# Hi-Fi Products Service Bulletin

**Model:** RM-S2070K

**No. 265**

**Subject:** Compatibility With Older Models

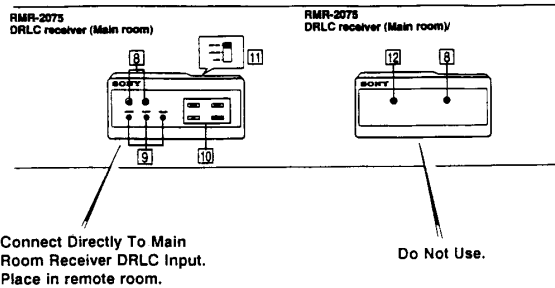
Although the RMS-2070K Users Guide indicates incompatibility with older model units, such as the STR-AV920/1020 and STR-D2020, it is possible to use the unit with these models.

When using the RMS-2070K with older model units, the main room repeater RMR-2075 cannot be used. The RMR-2070 remote room receiver should be connected directly to the main room receiver DRLC input. This allows for control of functions previously available when using the RMS-2020K DRLC unit (source selection, remote room volume and remote room tuner presets). The other functions on the RMS-2070K hand held remote will not function (CD Control Functions and Tape Deck Control Functions).

**Functional**

1. DRLC Power
2. SLEEP
4. Main & Function Buttons
5. Tuner Preset Buttons
6. Volume Control Buttons
7. Power-Off

**Non-Functional**

3. Operation Buttons/Learn Buttons CD Control
